REF. EXTRUSION # 8001016
(DRAWING # A3725)

5231246 - STANDARD PLATE
5231286 - CABLE OPERATED SLIDE ONLY

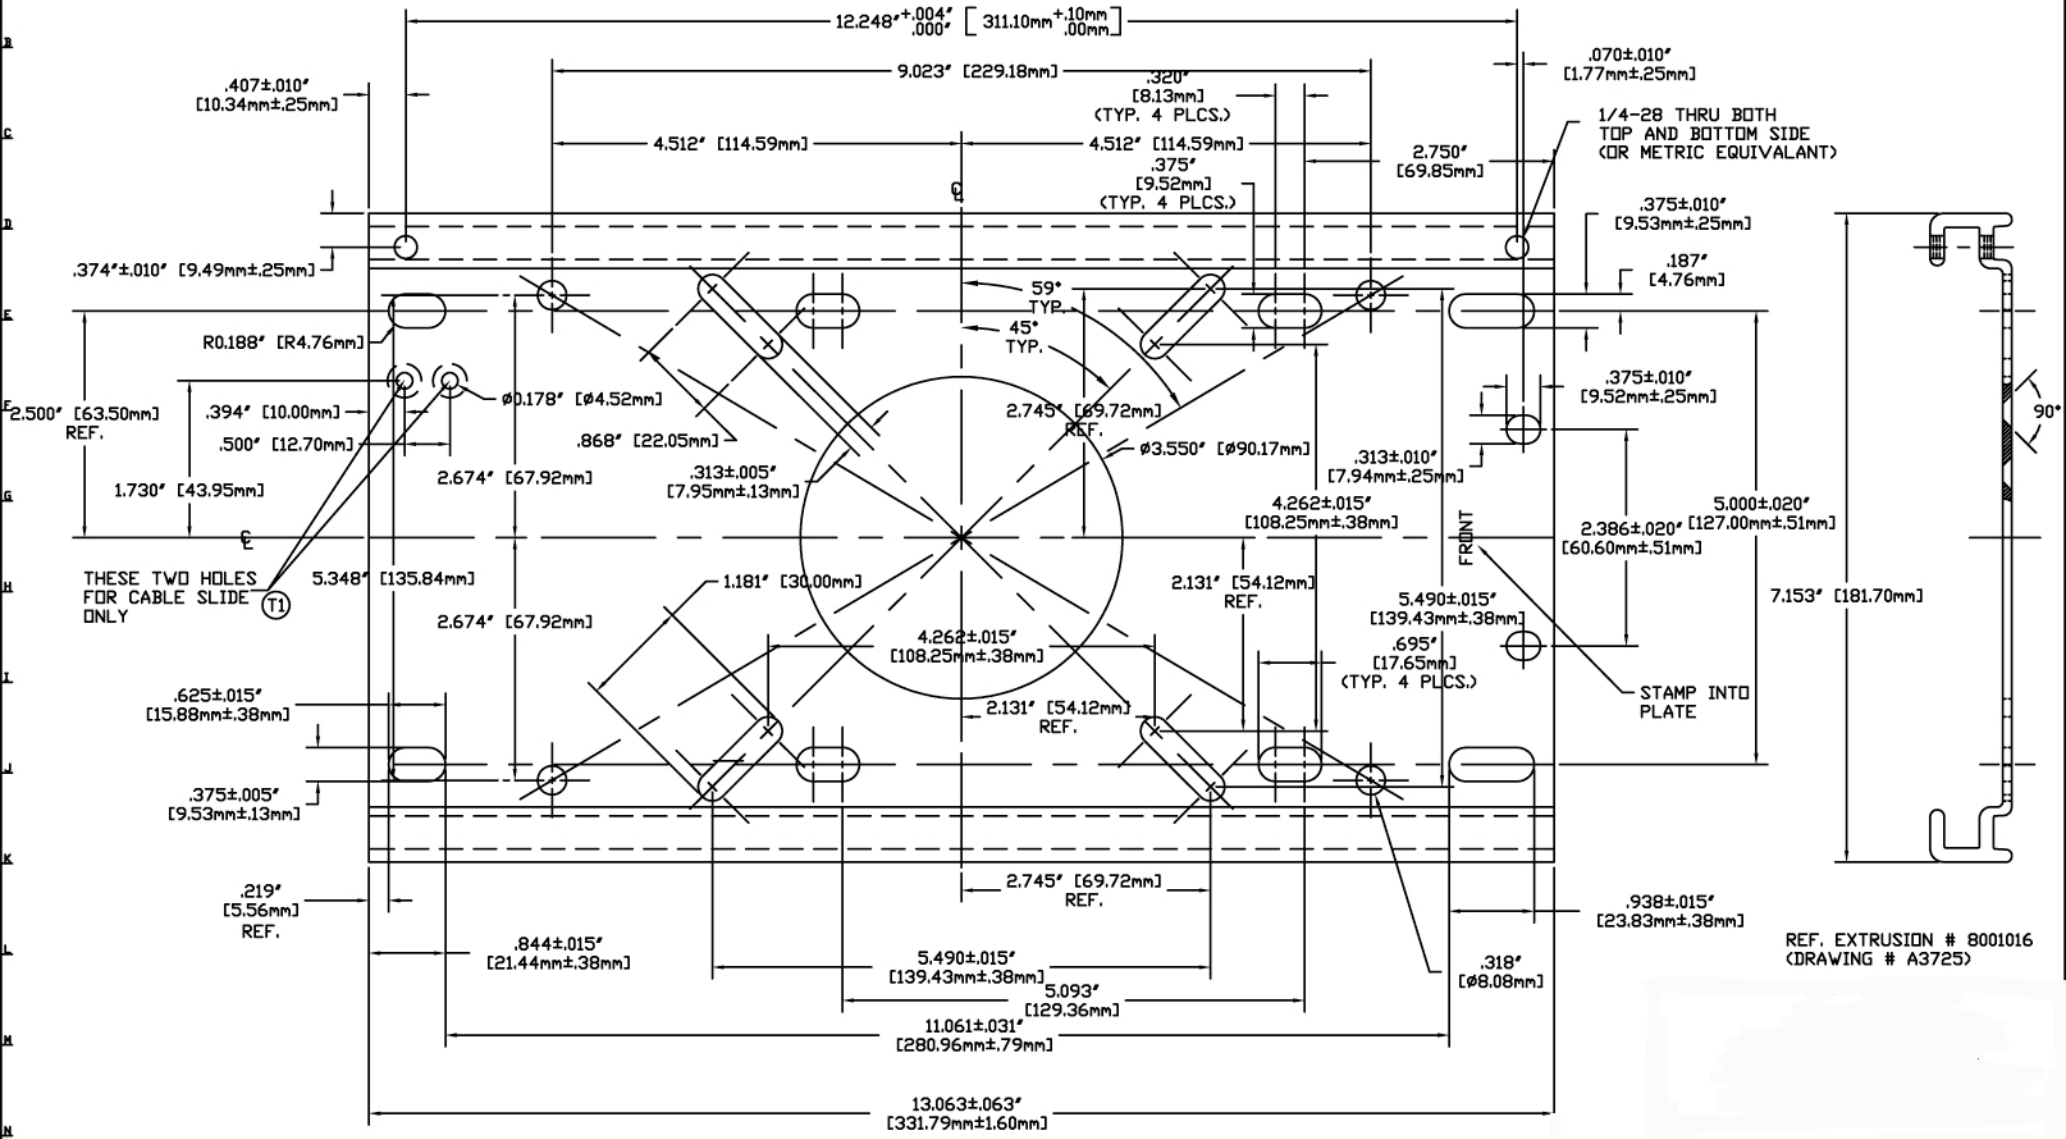
REV.	X-Y	ECN	ITEM REVISED	ITEM BEFORE REV	AUTHORIZED BY	BY DATE
T1	3-H	1109	CHANGED LOCATION OF TWO HOLES	SEE PREVIOUS DWG		07/08/08

*HOLES MUST BE OFF-CENTER TOWARDS THE FRONT OF THE SLIDE
